ARM Group LLC

Re: Comment Response Letter:
Phase II Investigation Work Plan
Area B: Parcel B11 (Revision 0)
Tradepoint Atlantic
Sparrows Point, MD 21219

| Parcel B11: Proposed Soil Borings Aerial View June 1, 2020 | | Figure 4 |

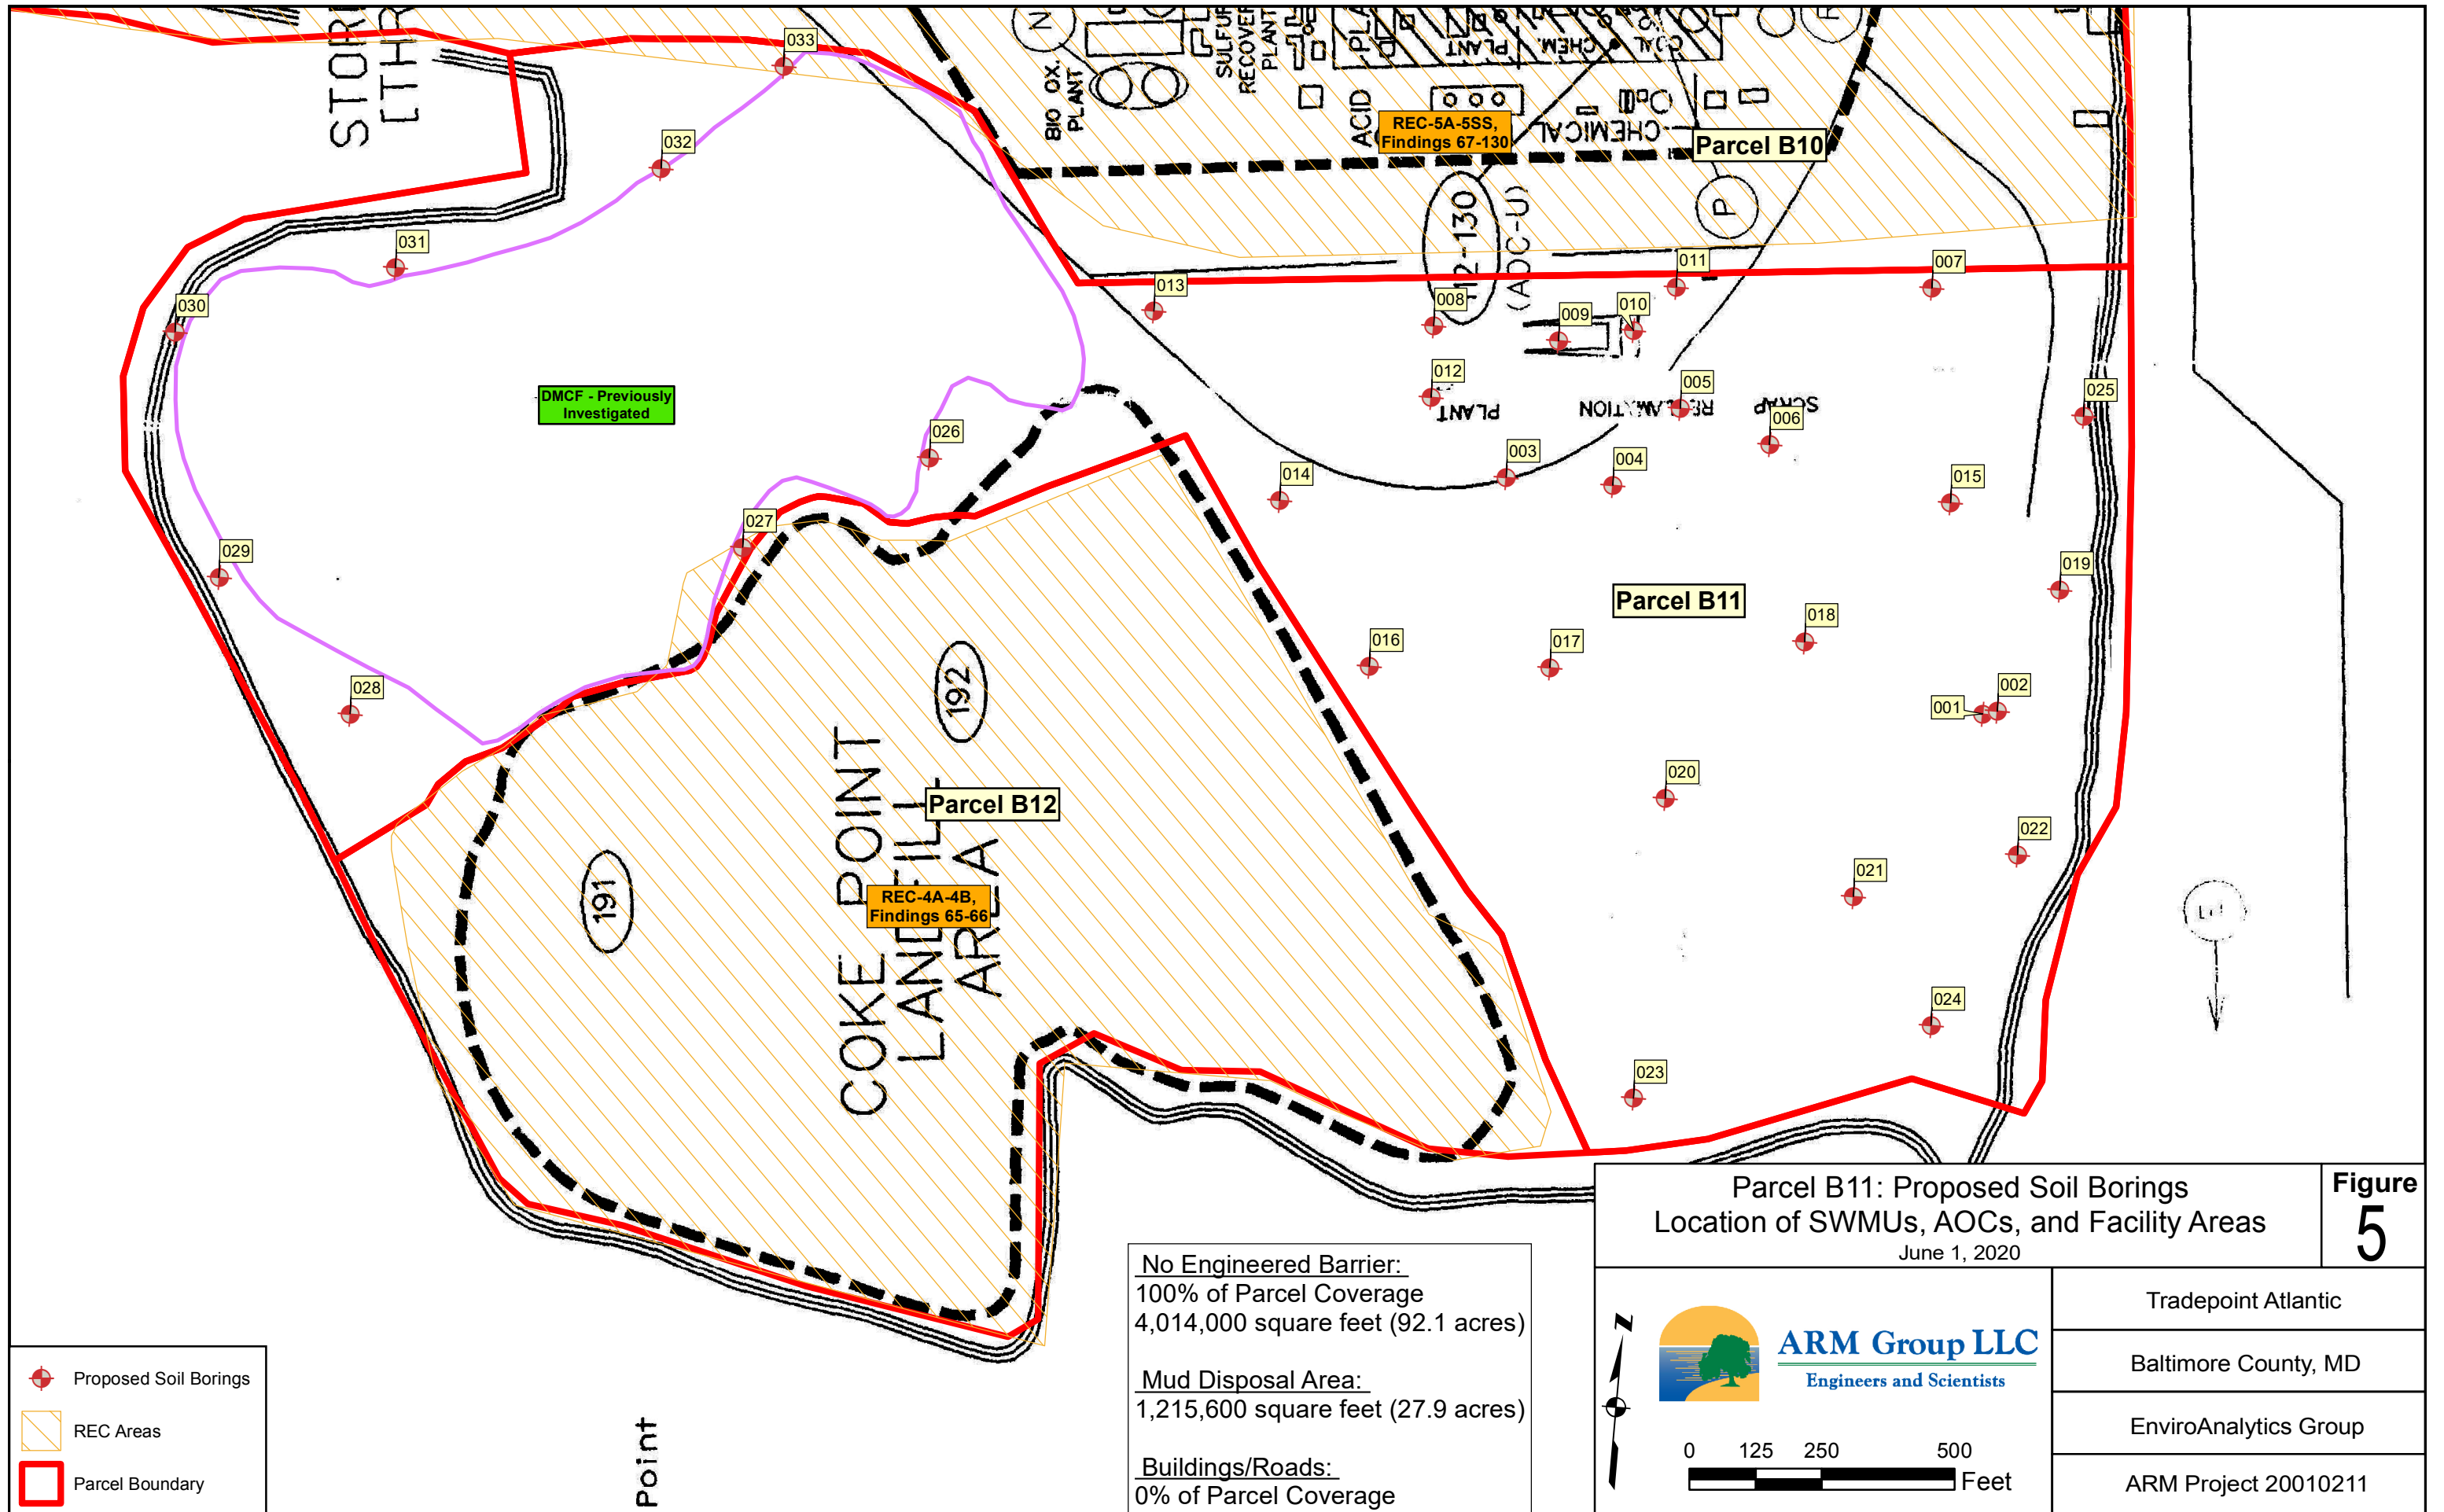
- 1. Depending on the final proposed grade after slag removal/processing, if any, additional samples may be required. Provide a statement regarding anticipated final grade of this parcel.*

Tradepoint Atlantic provided aerial survey data for the Coke Point Area (CPA) including Parcel B11. Upon review of this data, the locations of several borings have been adjusted slightly to areas that have current elevations of 12 feet amsl or below. Some locations were also shifted to move them off sloped areas for ease of access. When locations were shifted, care was taken to ensure each soil boring continued to target any features of environmental concern that had previously

been targeted for sampling in the Parcel B11 Work Plan (Revision 0). The final selected locations are shown on the attached **Figure 4** through **Figure 9**, which have been updated from the original Work Plan submission. **Figure 9** specifically presents the topographic mapping. Tradepoint Atlantic also provided electronic (CAD) files which allowed for detailed review of the elevation data.
